SPIRIT LAKE FISH HATCHERY
UPGRADE TO RAS SYSTEM
DICKINSON COUNTY, IOWA
PROJECT NUMBER: 21-01-30-01

Date September 11, 2020

This Addendum is issued to modify, explain or correct the original Drawings and Specifications, and is hereby made a part of the Contract Documents. Please attach this Addendum to the Project Manual in your possession. Insert the number and issue date of this Addendum in the blank space provided on the Proposal Form.

SHEET | **X-1R**

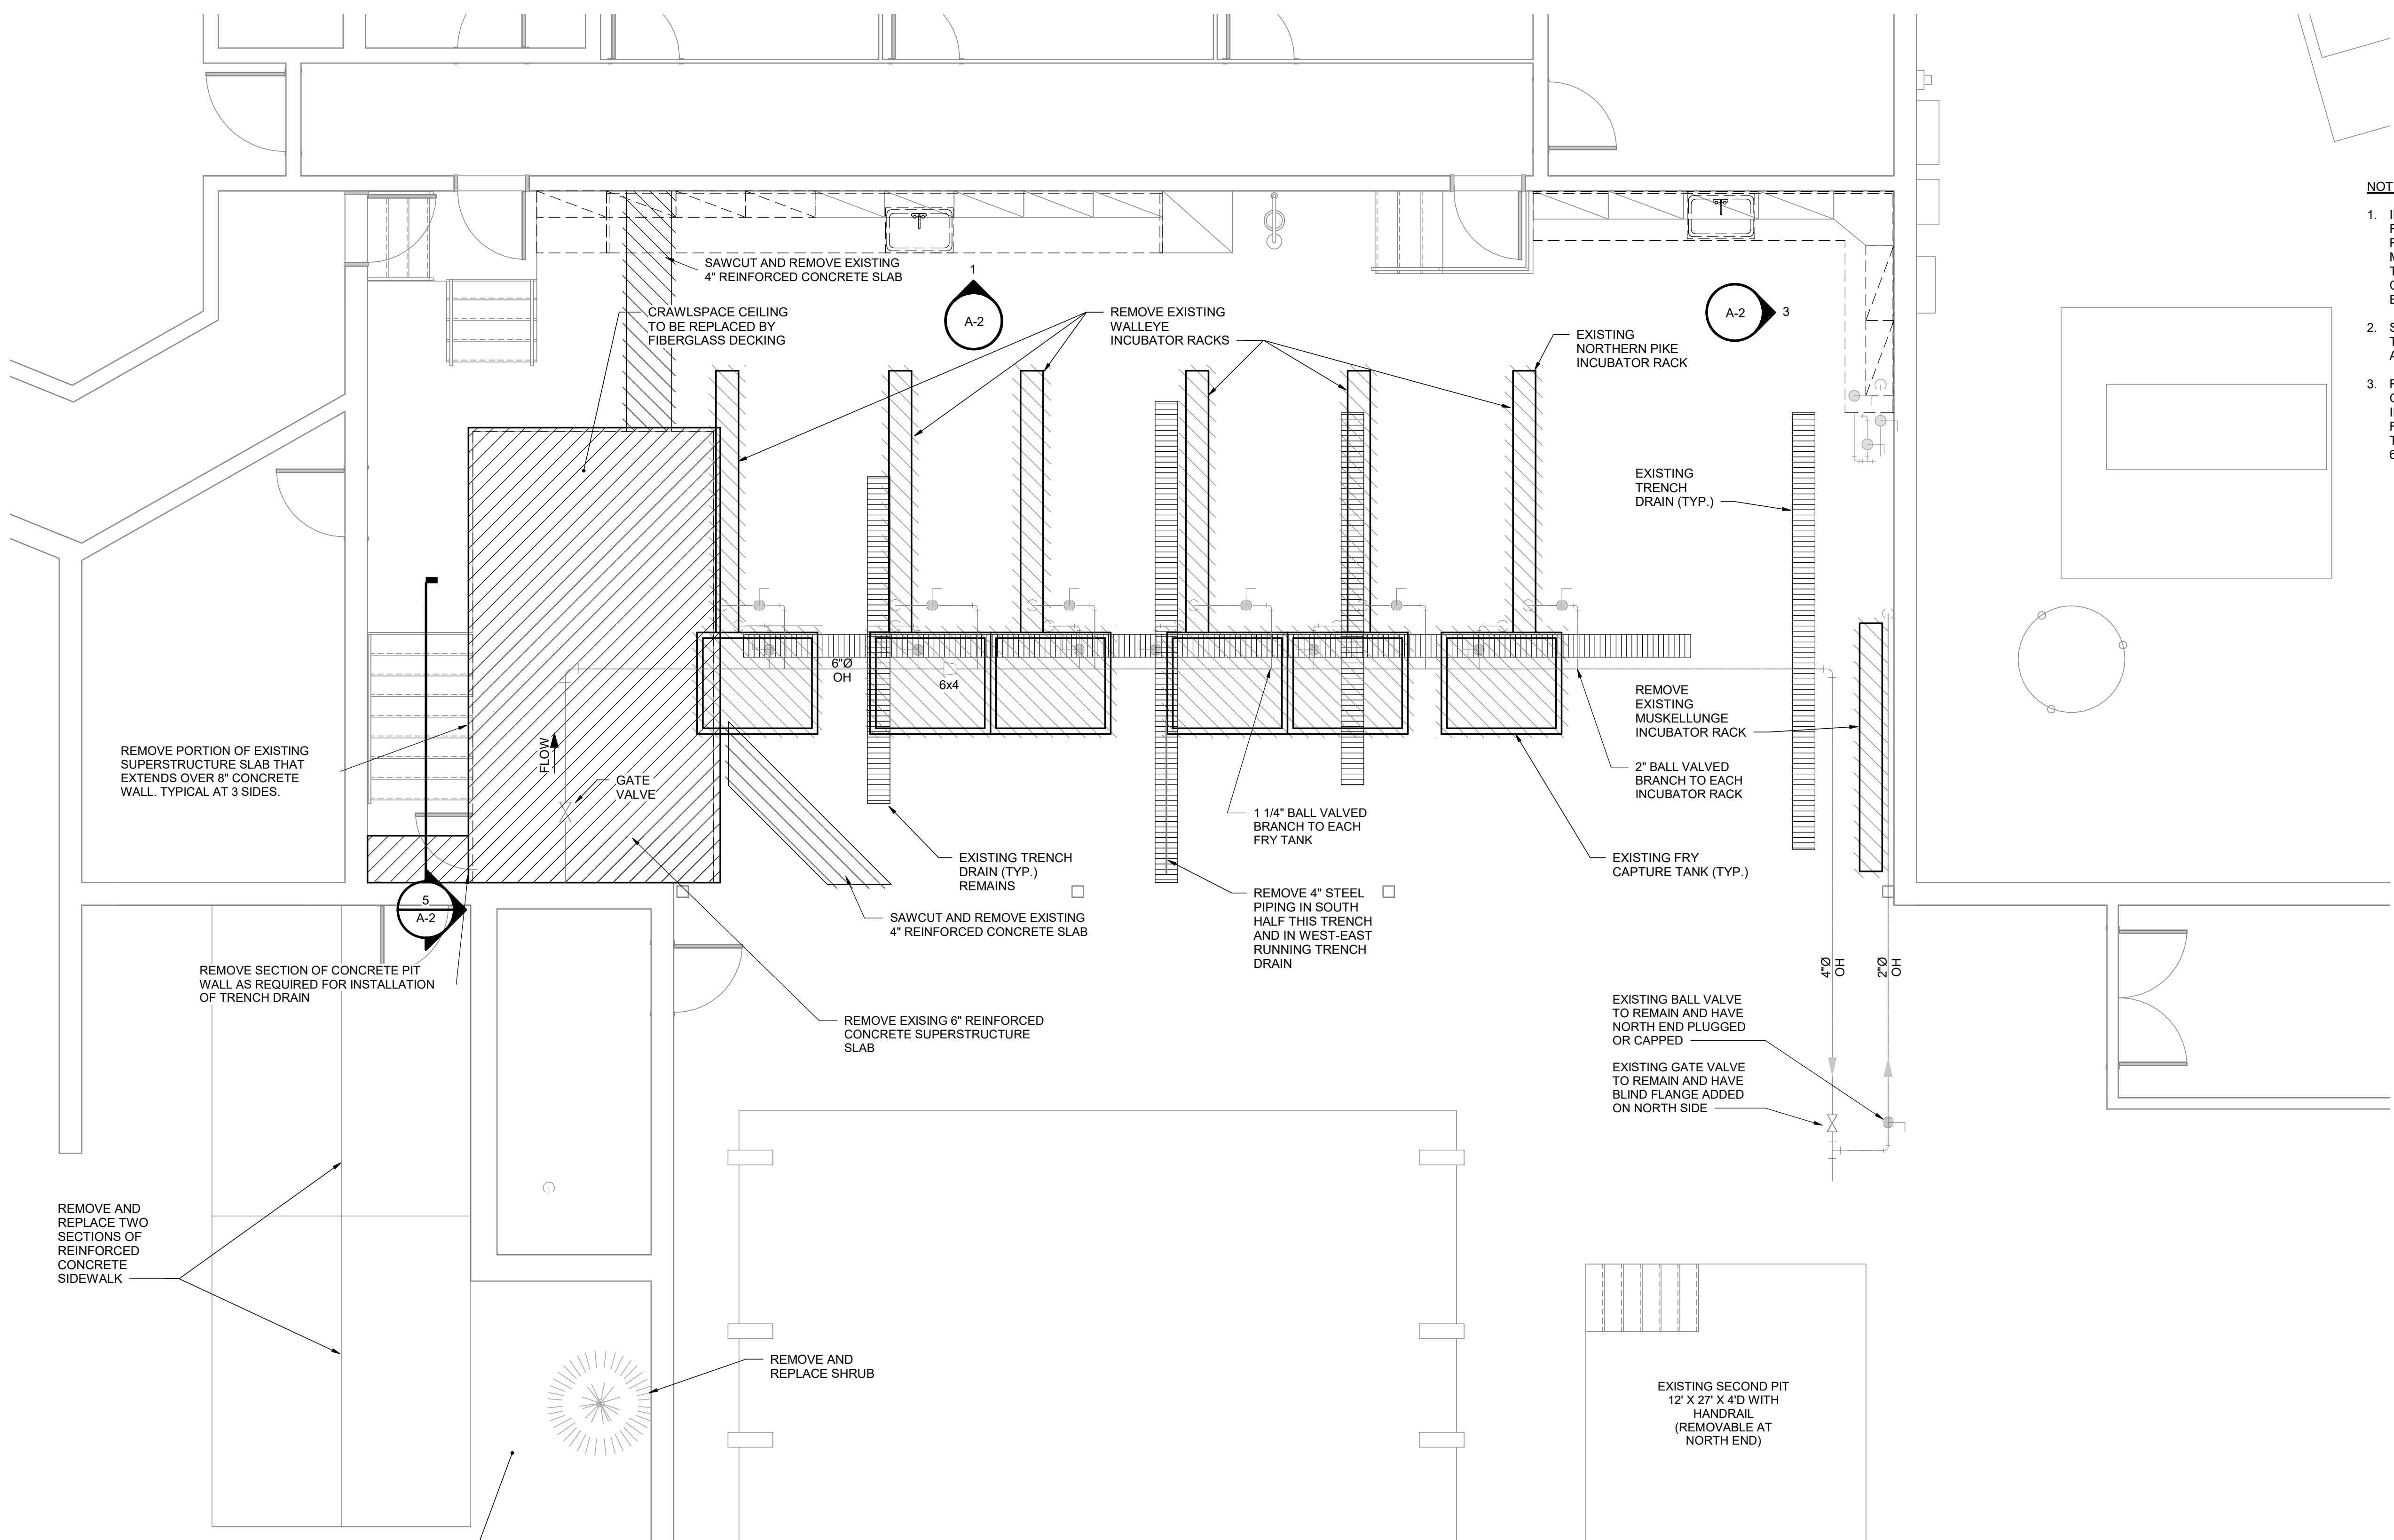
Outside, south of the stairs, are two slabs shown to be removed and replaced on Sheet X-1. Replacement slabs shall be thickness to match existing (6” thick for bidding purposes) and shall be reinforced with #4 bars @ 6” O.C. each way, mid-depth. Dowel and epoxy grout bars 4” into adjacent slabs. Provide lean concrete/flowable backfill under slab in any areas that demolition leads to over excavation.

0 1" 2" FILENAME HDRE_ALL_DISCIPLINES.ne SHEET D-3R

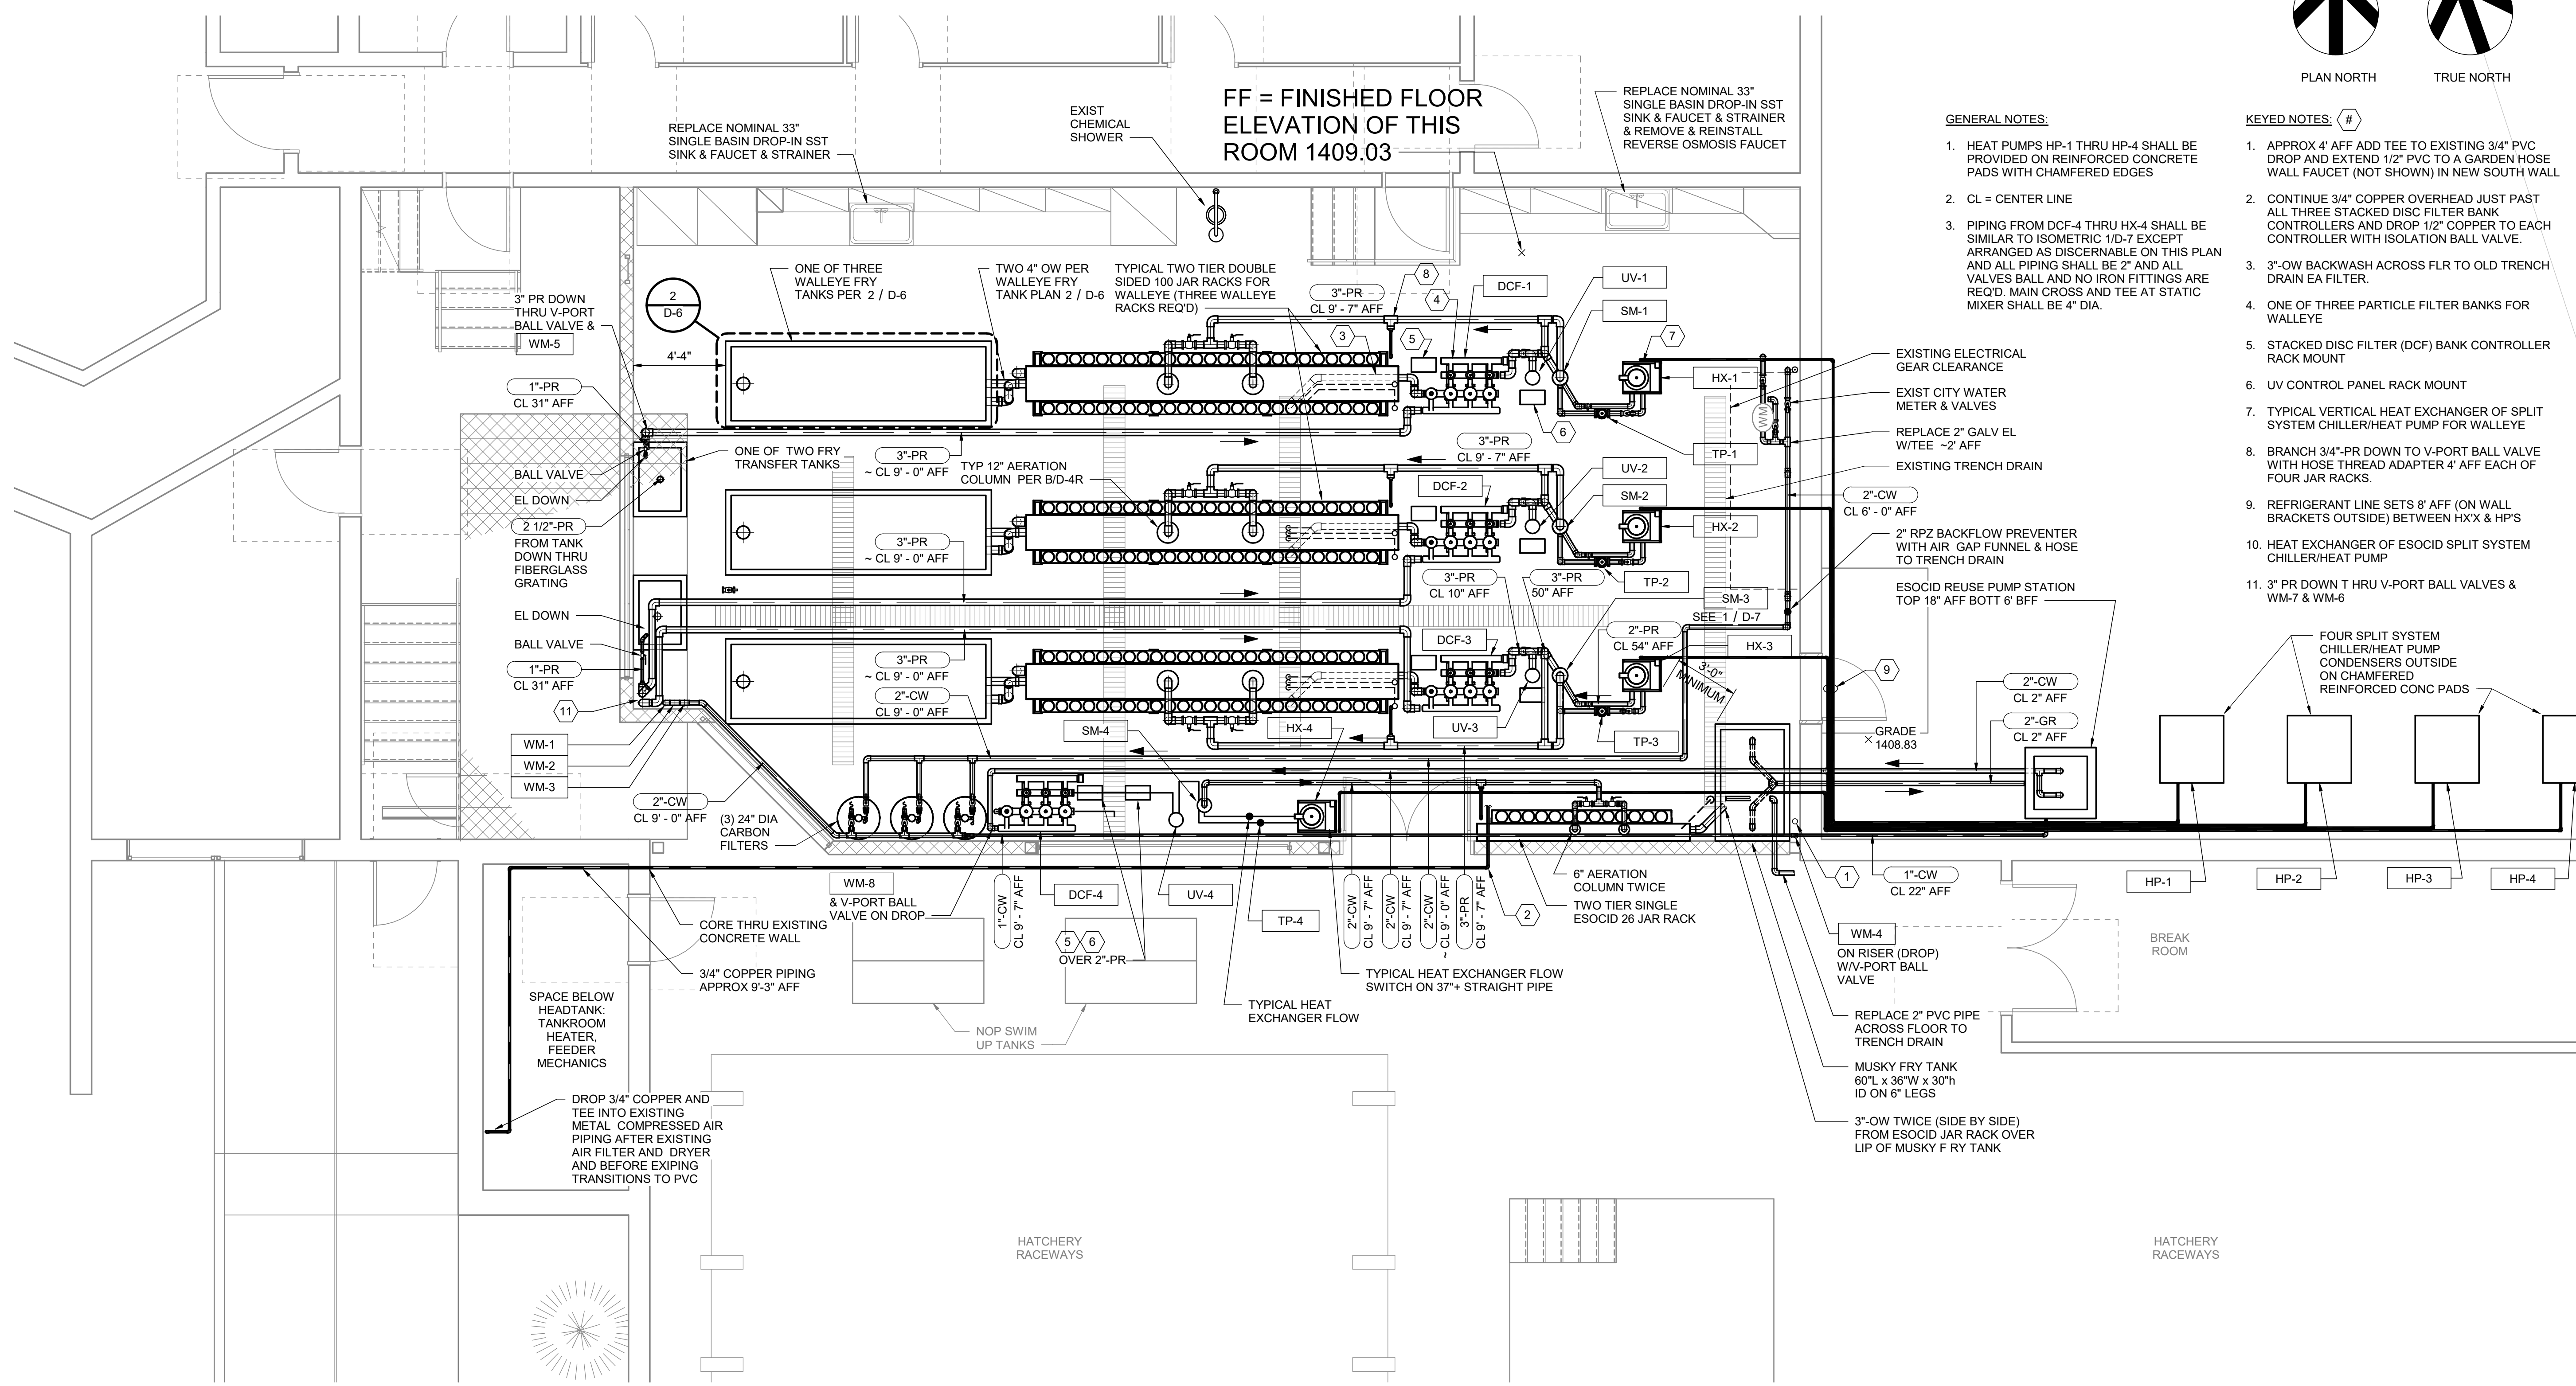
Cut and patch &/or core drill concrete in places indicated on D-2 (including addenda to D-2) and per D-3R.
